REMARKS

This application pertains to a novel bandage for the shoulder and upper arm area. Claims 1-20 are pending.

Figure 3

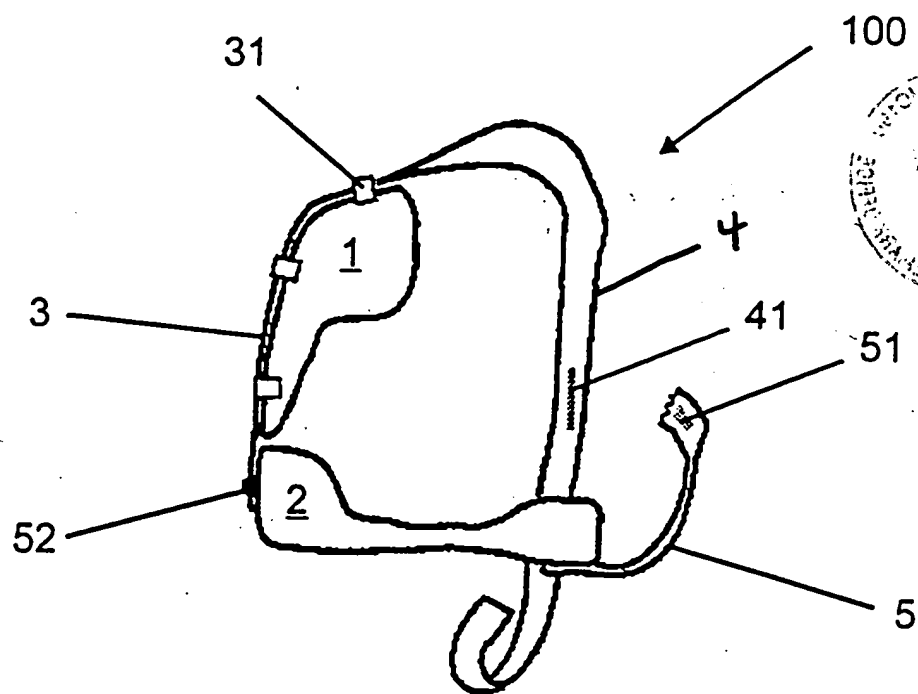
Applicants also respectfully request consideration and approval of the proposed corrections shown in red on the enclosed copies of Figures 3 and 4. The correction in each case is the addition of a designating line "4" to identify the shoulder strap. Support is found at page 8, line 10.

Figure 5

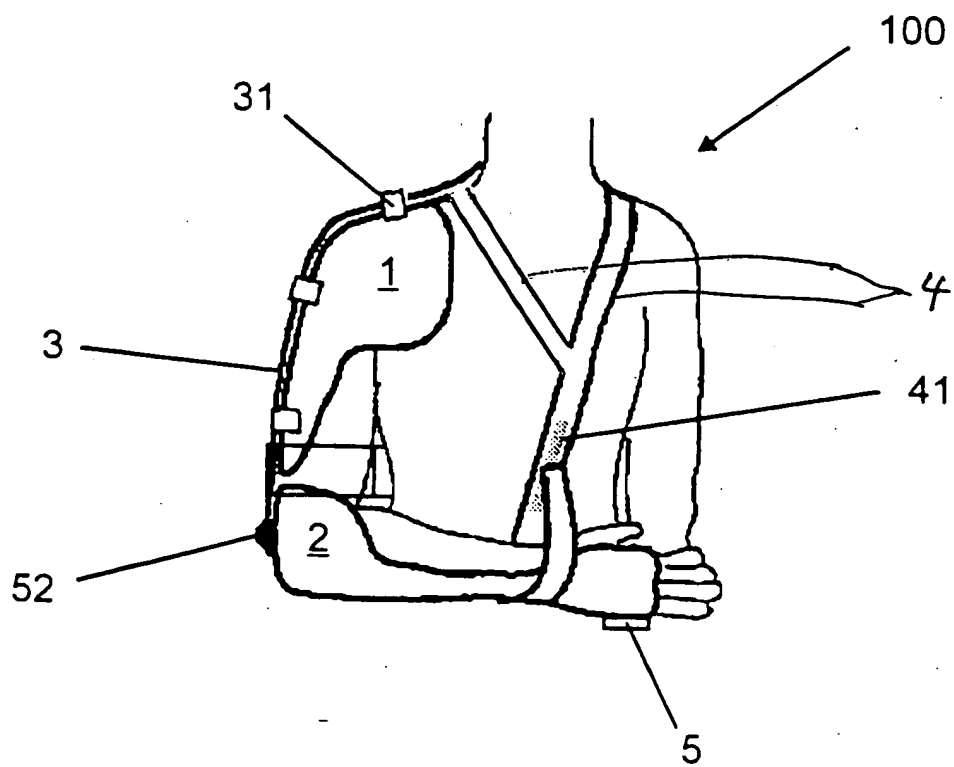
The drawings stand objected to because the support strap designed partially divided in two parts immediately after the attachment point on the shoulder cap as recited in claim 9 must be shown.

Applicants have now provided a proposed new Figure 5 which illustrates that which is described in the foregoing sentence. Figure 5 shows the bandage applied as shown in Figure 4, wherein the support strap 4 is partially divided into two parts, one part shown running ventrally over the thorax and the other part running dorsally over the thorax (illustrated by broken lines). No new matter is added, as the drawing illustrates only that which is disclosed in the original specification, as discussed above.

Not approved
9-24-02-CP
